ADDENDUM NO. 1

TO THE TERMS OF REFERENCE (TOR)

Enterprise Resource Planning (ERP) System Implementation

Subject: Clarification on Core Banking System (CBS) Requirement for Bidders

2. Clarification: Bidders proposing the Two-Tier solution option May Not Offer the Core Banking System (CBS)

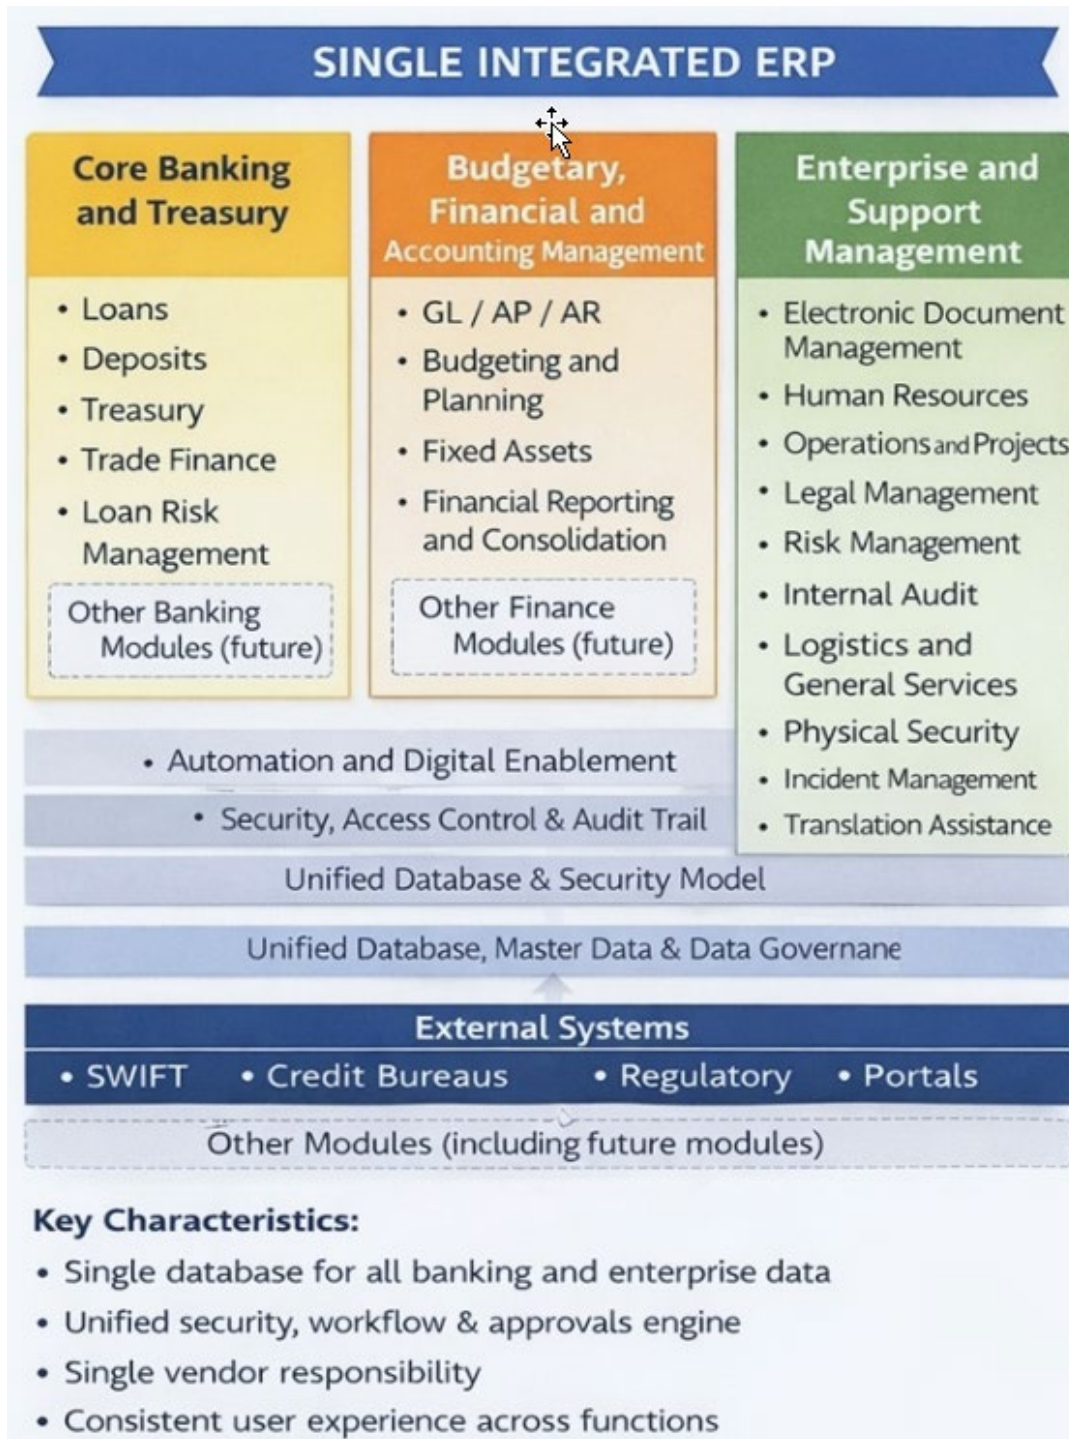
The TOR presents two solution architecture options for bidders to consider. A key point of clarification is provided below regarding the Core Banking System (CBS) component of the Two-Tier Architecture Option

Bidders are NOT Mandatorily required to provide or deliver a Core Banking System (CBS) as part of their ERP solution proposal if they do not have a standalone CBS that can be integrated with the proposed ERP. Bidders are only required to demonstrate that their ERP solution includes a robust integration engine capable of integrating with an existing and functional third-party CBS. However, bidders with a standalone CBS or 3rd Party CBS solution that can be integrated with the proposed ERP may submit a bid for the Two-Tier CBS and ERP solution option.

Option B — Two-Tier Architecture

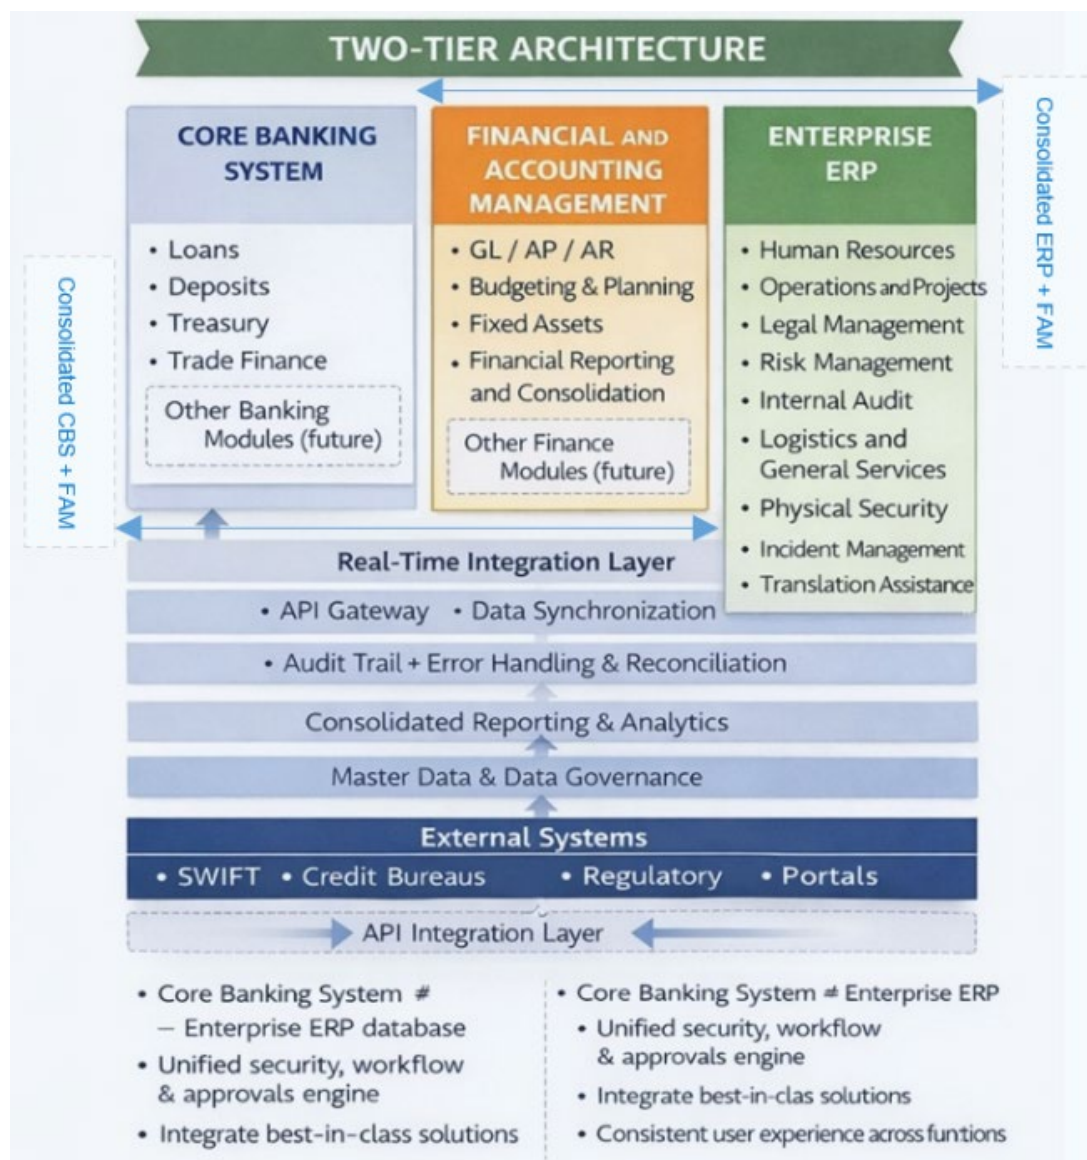
A layered architecture where banking operations are delivered through a dedicated Core Banking System (managed separately by EBID), while enterprise management functions are delivered through the bidder's ERP platform. Under this option:

- Bidders do **not** need to provide the CBS where they do not have a standalone Core Banking Module or compatible third-party Core Banking solution for integration.
- Bidders who have a standalone Core Banking Module may offer Core Banking and ERP as a Two-Tier Architecture solution.
- Bidders must demonstrate that their ERP solution includes a robust integration engine capable of connecting to third-party systems, including EBID's existing or future Core Banking System.
- The two environments will be integrated through a secure, real-time integration layer, with consolidated reporting and analytics across both domains.
